Project	IEEE 802.16 Broadband Wireless Access Working Group <a href="http://ieee802.org/16">http://ieee802.org/16</a>
Title	Clarifications for AAS Zone Allocations
Date Submitted	2005-1-10
Source(s)	Dave Pechner, Doug ArrayComm Inc. dpechner@arraycomm.com, dahlby@arraycomm.com,   Dahlby, Todd Chauvin chauvin@arraycomm.com,
Re:	IEEE P802.16-REVd/D5
Abstract	This contribution introduces clarifications for making allocations in an AAS zone in the OFDMA PHY
Purpose	Adopt into P802.16d/D5 corrigenda
Notice	This document has been prepared to assist IEEE 802.16. It is offered as a basis for discussion and is not binding on the contributing individual(s) or organization(s). The material in this document is subject to change in form and content after further study. The contributor(s) reserve(s) the right to add, amend or withdraw material contained herein.
Release	The contributor grants a free, irrevocable license to the IEEE to incorporate material contained in this contribution, and any modifications thereof, in the creation of an IEEE Standards publication; to copyright in the IEEE's name any IEEE Standards publication even though it may include portions of this contribution; and at the

Figure 222a—Example of UIUC = 12,13 allocation rules

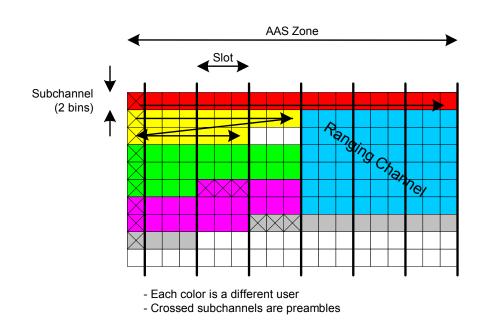
The following figure depicts correct and incorrect allocations of UIUC = 12,13 regions. Each rectangle is an UL-subframe (or zone). Regions 1,2,3 are correct allocations, and 4,5 are incorrect allocations.

This clarifies that UIUC 12, 13 allocations are not allowed to break the UL tile structures. A similar strategy is followed to define restrictions in the UL AAS zone to insure that the tile structures are not broken in the presence of AAS UL preambles.

Example 1 – UIUC 12 region is an integer number of slots

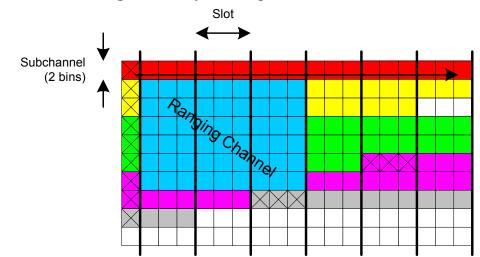
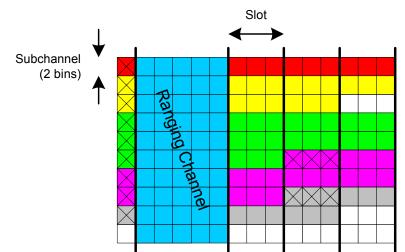
The following figures show valid UL AAS Zones.

### 8.4.4.6.3 AAS Preambles

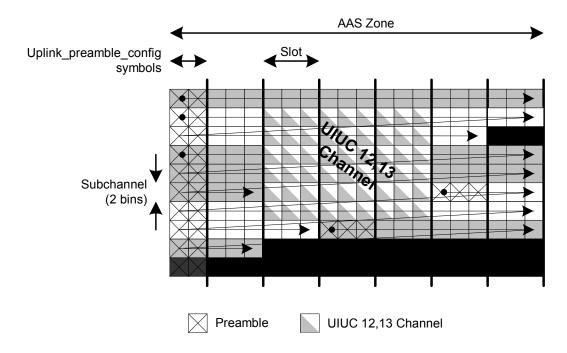
The optional AAS-DLFP is preceded by an AAS downlink preamble of one symbol duration. All other-D DL bursts with DIUC 0-12 within the an AAS DL and UL zones have a preambles whose durations are is specified by the <u>"Uplink\_preamble\_config"</u> field of the AAS\_UL\_IE and "Downlink\_preamble\_config" fields of the AAS\_DL\_IE. These- This fields will be consistent with the same fields of the AAS\_DLFP if present. In the case the AAS DL Zone is using the PUSC permutation, the "Downlink\_preamble\_config" shall always be set to an integer number of slot durations (i.e. 0 or 2 symbols).

An UL preamble is inserted at the start of an UL data allocation with UIUC 1-10 and whenever such an UL allocation wraps from the end of an AAS zone to the beginning. The first Uplink\_preamble\_config symbols of the UL AAS zone are reserved for UL AAS preambles. On a given subchannel, an UL AAS preamble will be inserted into these symbols by the SS devices who is allocated the slot following the preamble (or following a UIUC 12,13 region if it directly follows the preamble). Any UL preamble inserted in an AAS zone in a location other than the first Uplink\_preamble\_config symbols shall be 3 symbols in duration.

The duration of an UL AAS zone minus the reserved uplink preamble symbols and any UIUC 12,13 allocations shall be an integer number of slots. To insure that UL tile structures are not broken due to an allocation wrapping, the following restrictions hold:

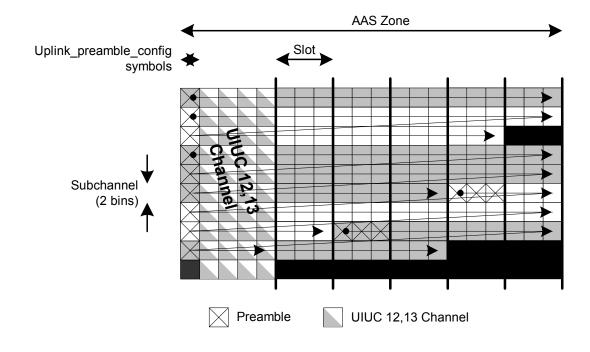
The figure below shows a legal UL AAS zone with an UIUC 12,13 allocation that is an integer number of slots in duration.
